Commonwealth Edison
One First National Plaza, Chicago, Illinois
Address Reply to: Post Office Box 767
Chicago, Illinois 60690

February 20, 1981

Subject: LaSalle County Station Units 1 and 2
Resolution of Safety Evaluation Report Issues
NRC Docket Nos. 50-373/374

In response to questions from the NRC Staff, information is provided herein to resolve remaining issues in the LaSalle County Safety Evaluation Report. The areas addressed are the following:

FIGURE #40.106-5
 FAULT CURRENT PROTECTION
 FOR LOW VOLTAGE PENETRATIONS

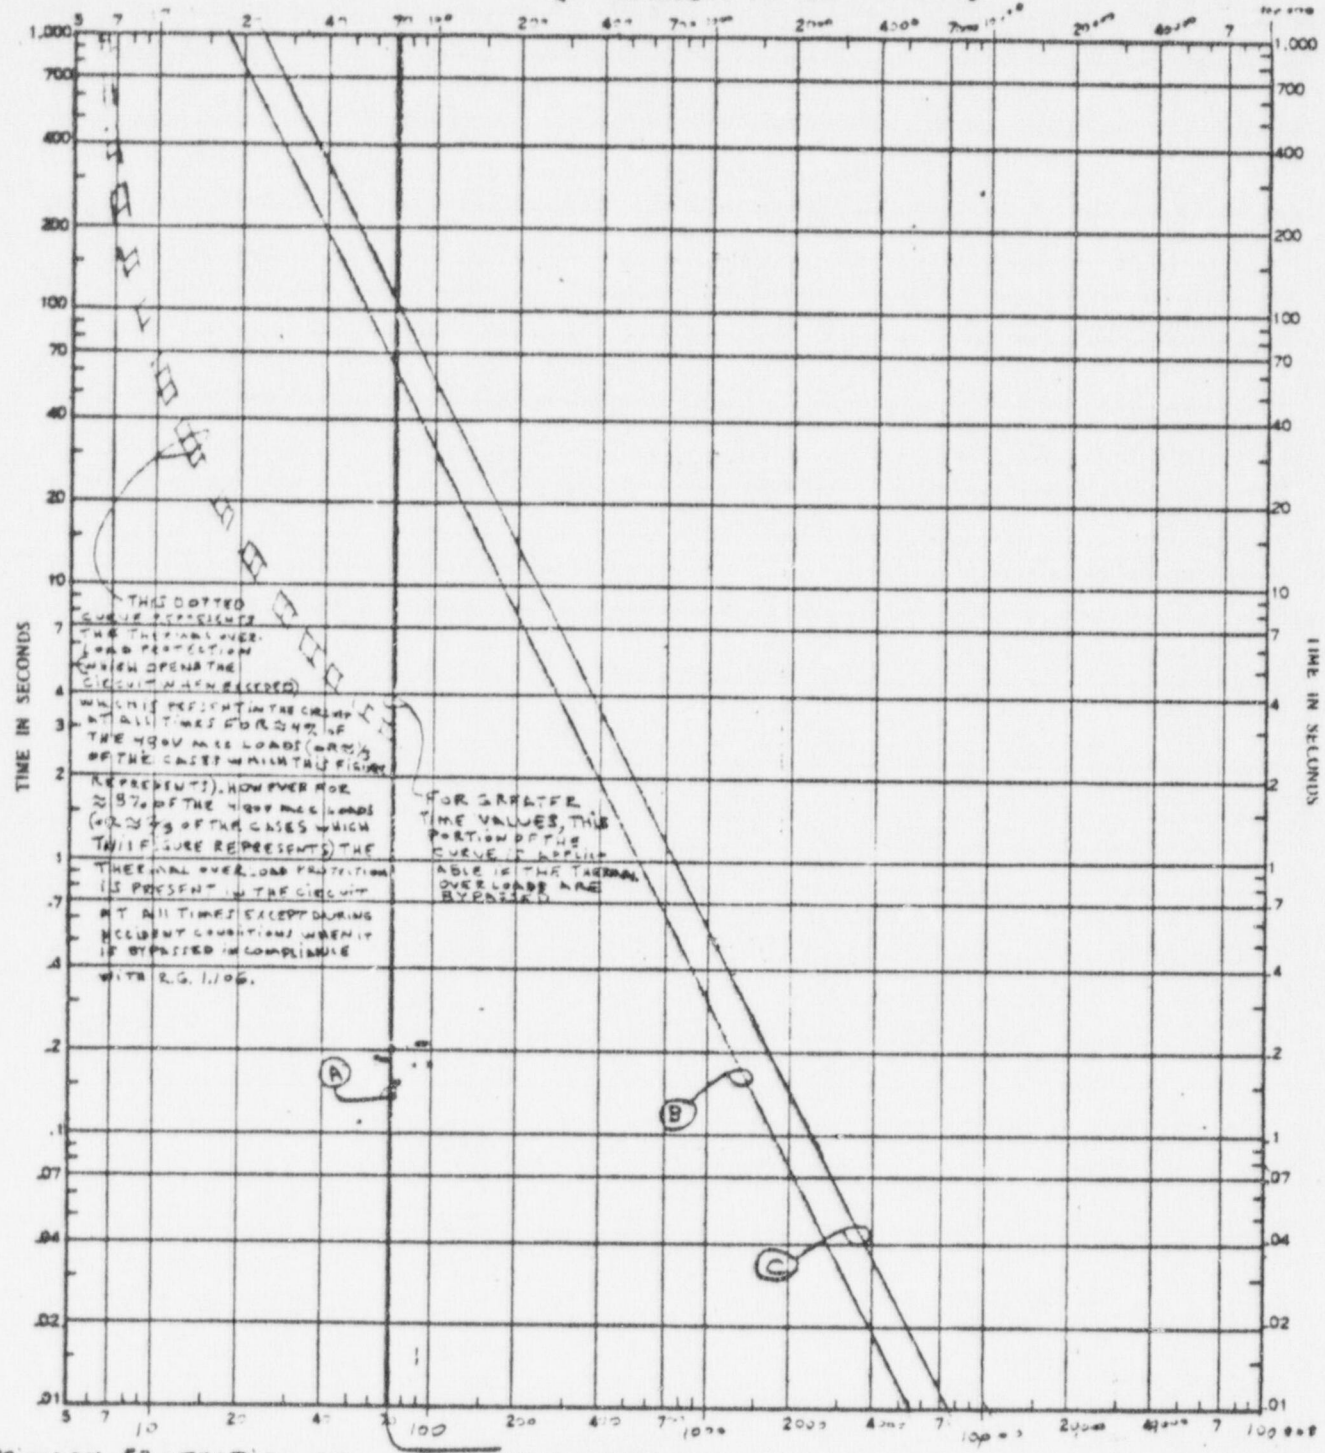
design does not take advantage of the oversized penetration conductor but rather has primary and backup ^{fault current} protection for the ELECTRICAL penetration assembly (EPA) as shown in Figure Q40.106-2. Coordination curves showing the primary and backup ^{fault current} protection for the low voltage penetrations are provided in Figures Q40.106-3, Q40.106-4, Q40.106-5, Q40.106-6 and Q40.106-7.

Also, Figures Q40.106-3, Q40.106-4, Q40.106-5, Q40.106-6 and Q40.106-7 illustrate that ample margin exists between the backup fault current protection and the conservative thermal limit capability curve of the electrical penetration.
